EXCOM Fashions Ltd. (relocated)

Nimertek, Rajfulbaria, Savar, Dhaka
(23.803371, 90.265160)

7th November 2021

Observations

East view

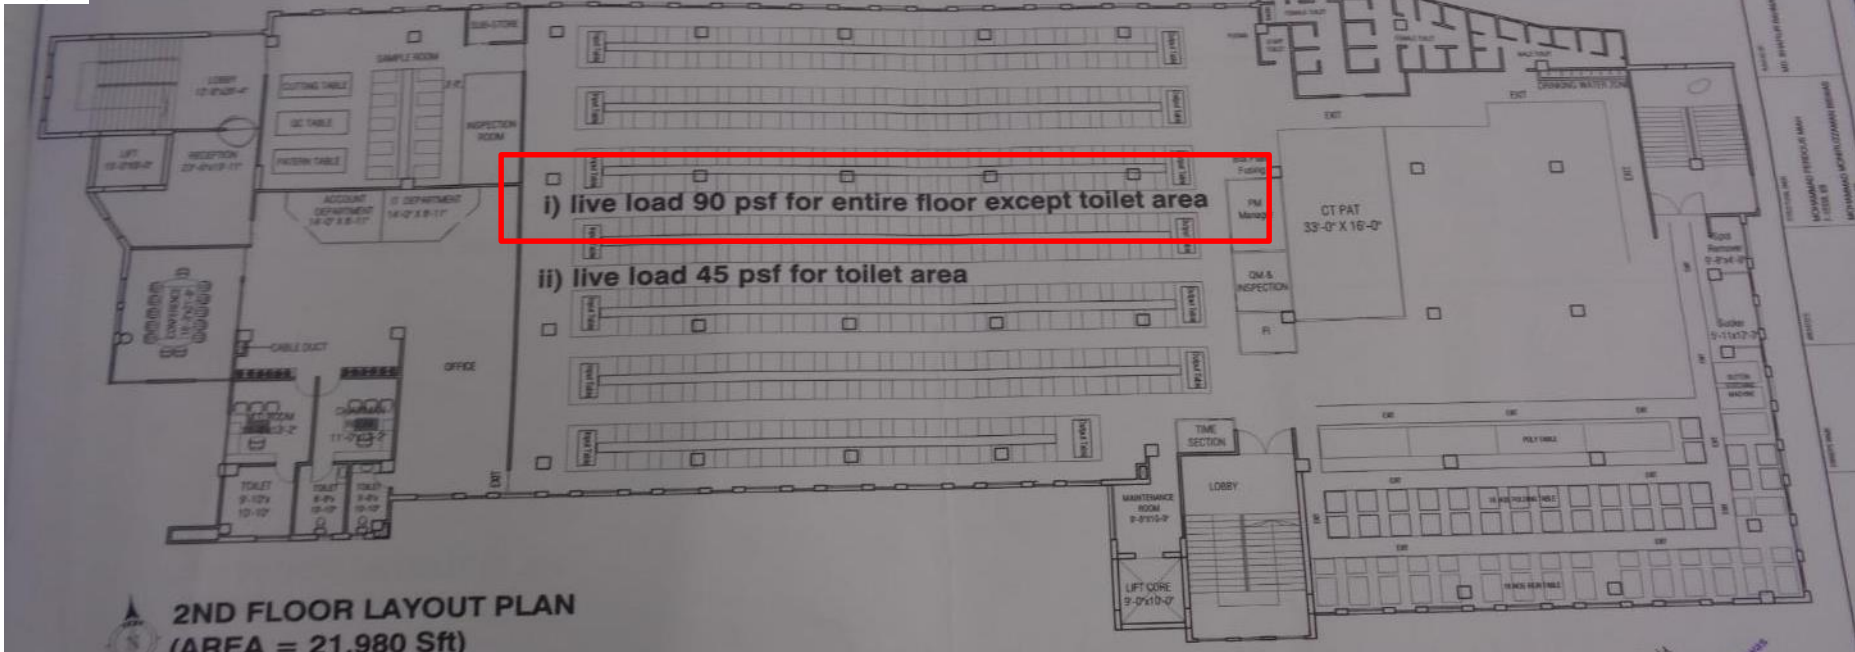
Design Report needs to be prepared

As per BNBC, every building or structure designed shall have its design documents prepared in accordance with the provision of Section 1.9.1. The design document shall include a design report, and a set of structural drawings, which shall be prepared in compliance with section 1.9.1.1 and section 1.9.1.2 as per BNBC. At the time of inspection, only as-built drawing was available, but no design report was available which is required to be prepared in compliance with section 1.9.1.1 (part-6, BNBC).

Live load plan- 2nd floor 4.28 kPa (90 psf)

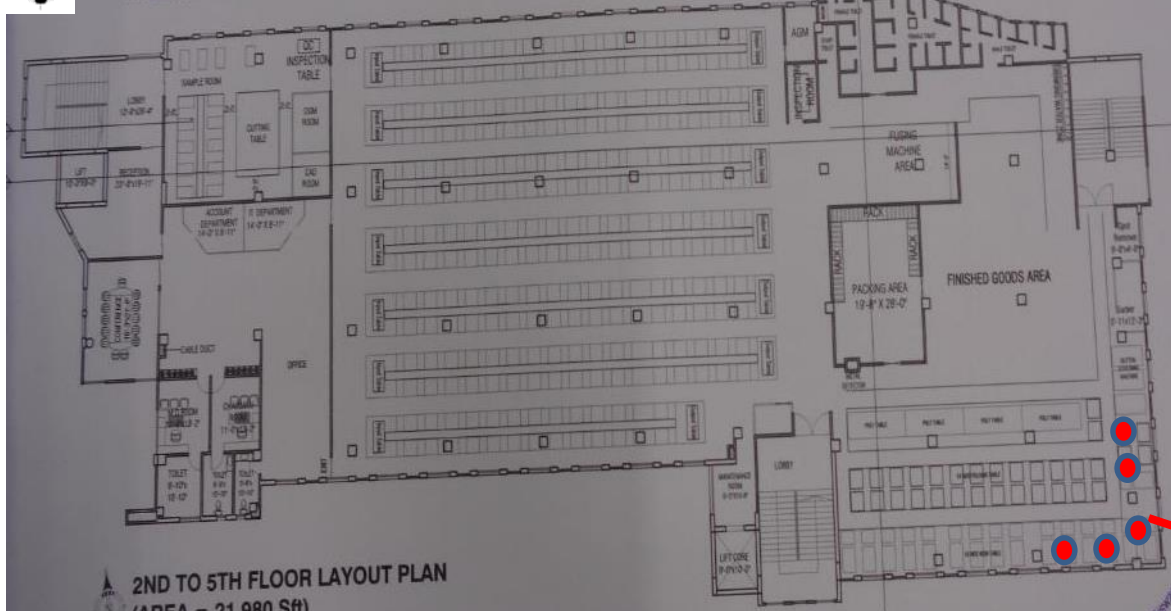
Prepared load plan to be revised

Live load on typical floor is considered as 4.28 kPa in prepared load plan. As per BNBC- Part 6, live load for light storage areas is required to be considered minimum 6 kPa. However, the factory engineer is required to revise the load plan as per BNBC requirement and check the design accordingly.

Roof layout

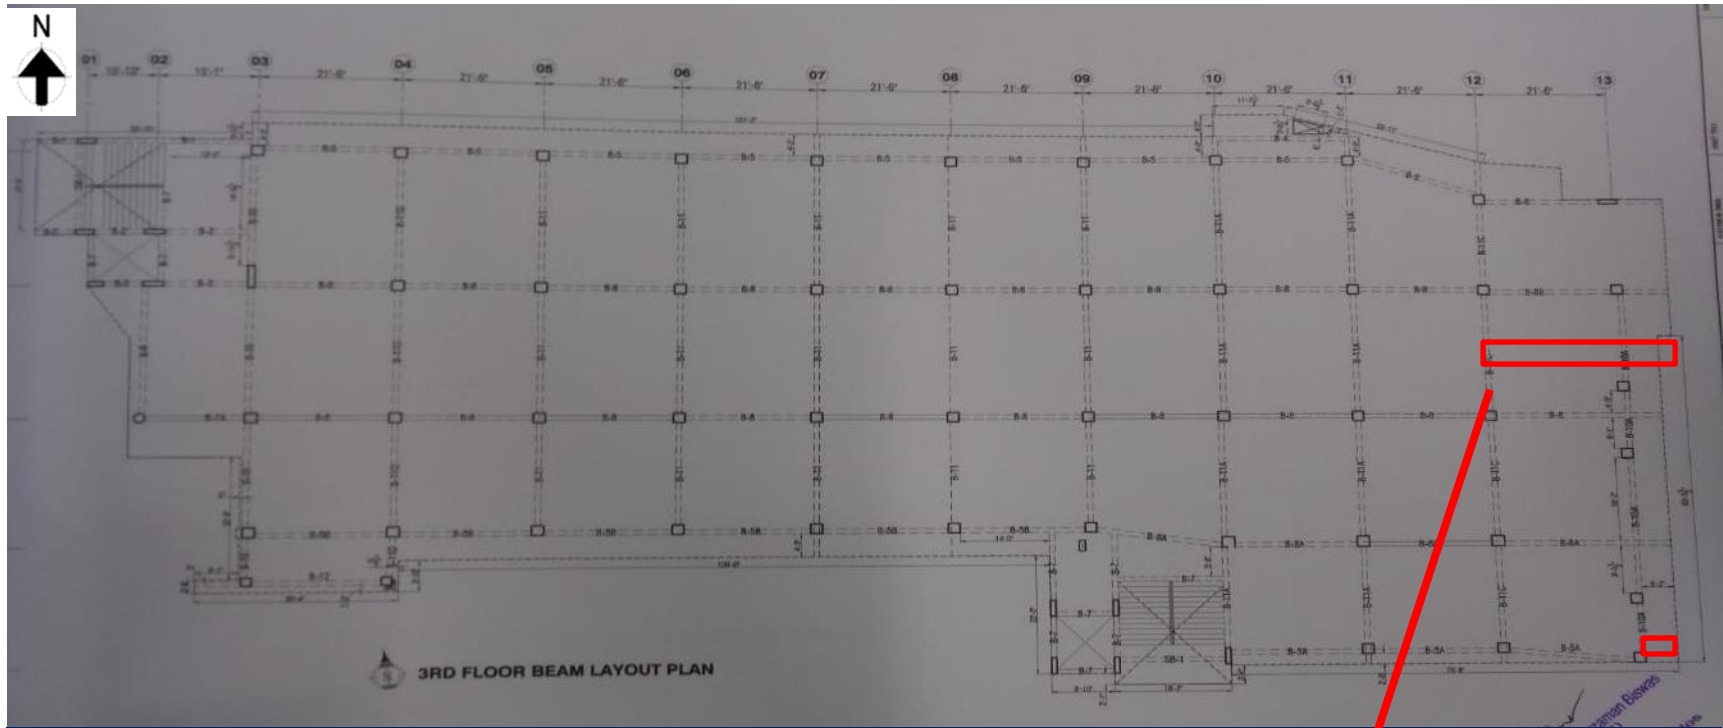
Discrepancy in as-built drawing

Five plastic water tank having capacity of 2000 litre each found on roof slab which were not shown in roof layout. Factory engineer is required to update the as-built drawing as well as check the capacity of roof beam-slab considering the point load.

Third floor (Existing roof) beam layout

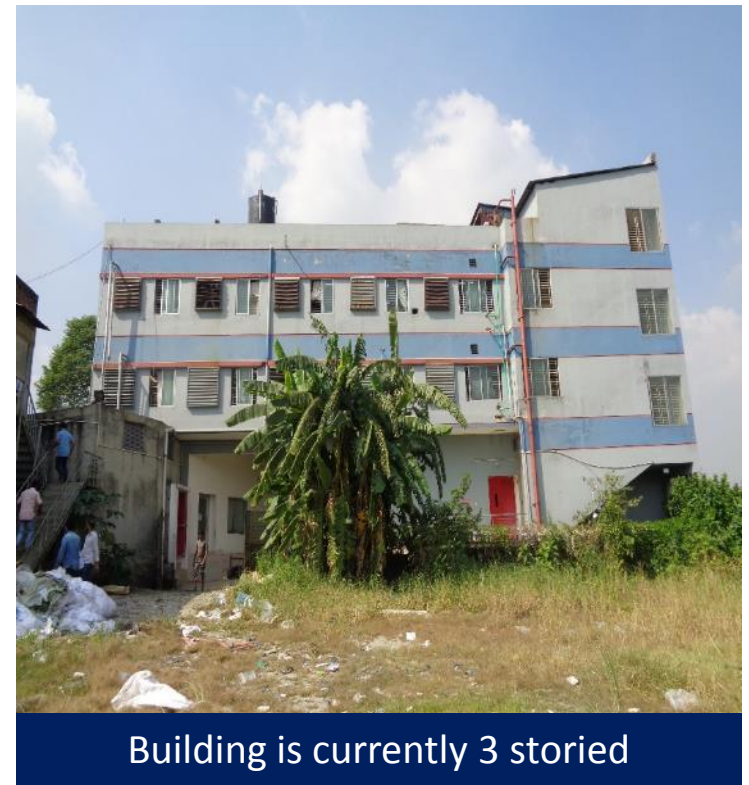
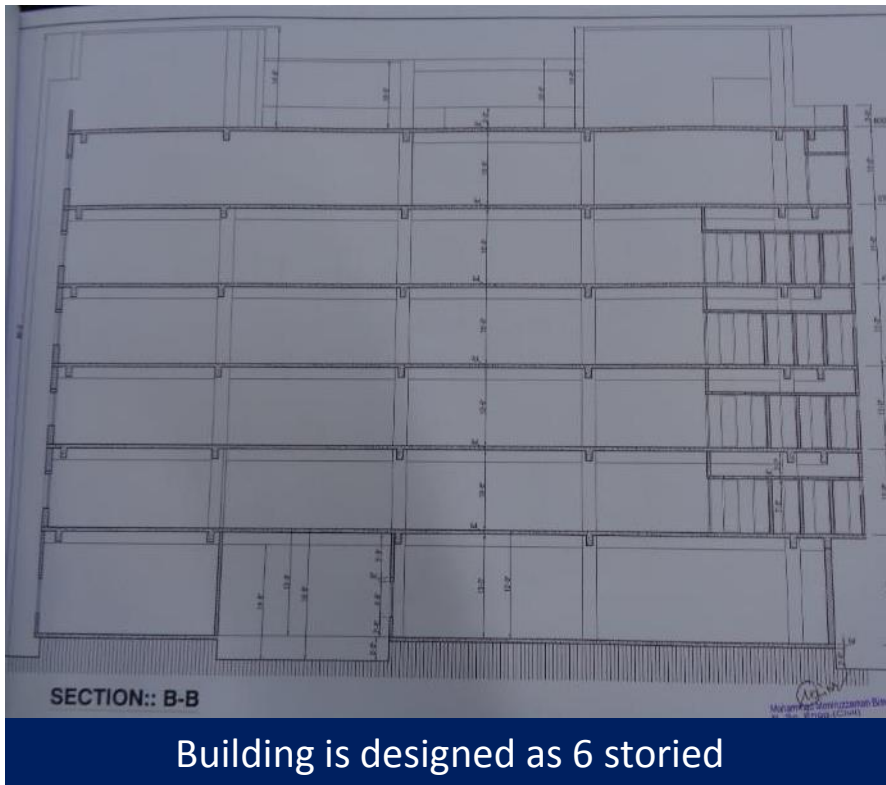
Highlighted beams were found onsite but not shown in drawing. Factory engineer is required to update the as-built drawing.

Possible vertical extension

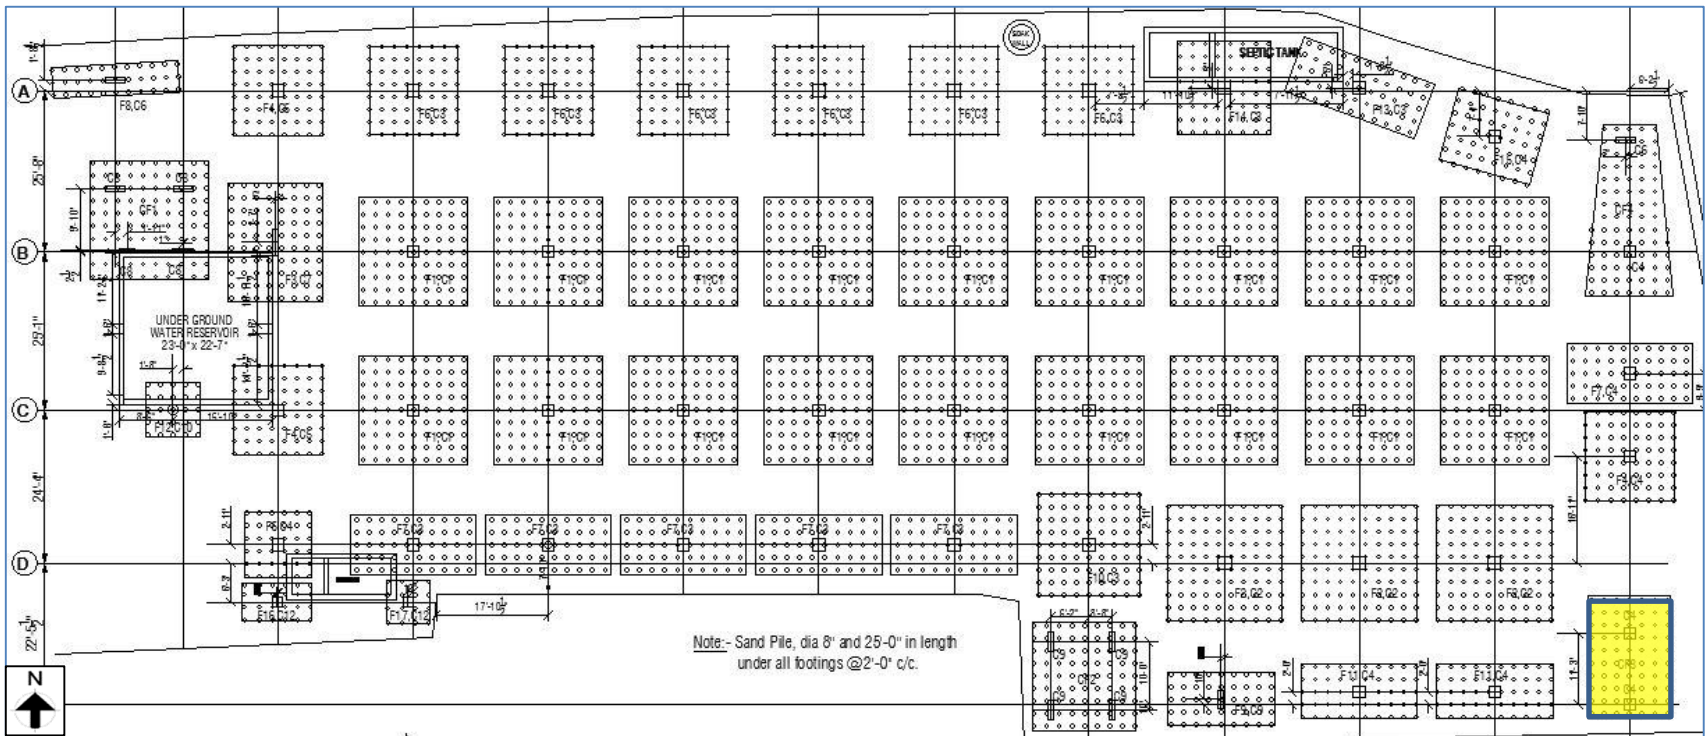
The building has permit drawing for 6 storied and factory is intended to conduct vertical extension in future. However, the building is currently existed as three storied.

Cursory calculation indicates the stress in highlighted column & foundation in layout will exceed normal design limit for above of 4 storied. Factory engineer is required to review, design of column and foundation stress in-case of conducting any vertical extension above 4 storied. Also, take 4-100 mm diameter concrete cylinder core from lower tier of the building to evaluate concrete strength of the existing column.

Lack of lateral stability of the roof shed

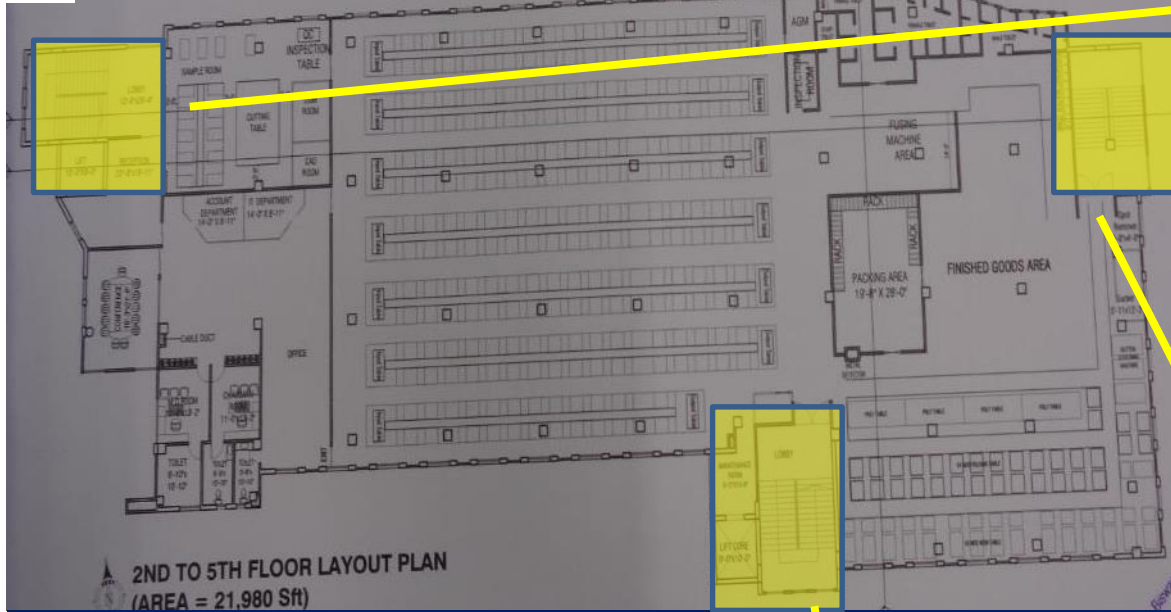
No framing (along periphery)/bracing system provided

Truss framing is provided along long direction at mid portion, but no compression member provided (along periphery). Also, roof bracing is not provided for roof. Factory engineer is required to check the lateral stability of the shed.
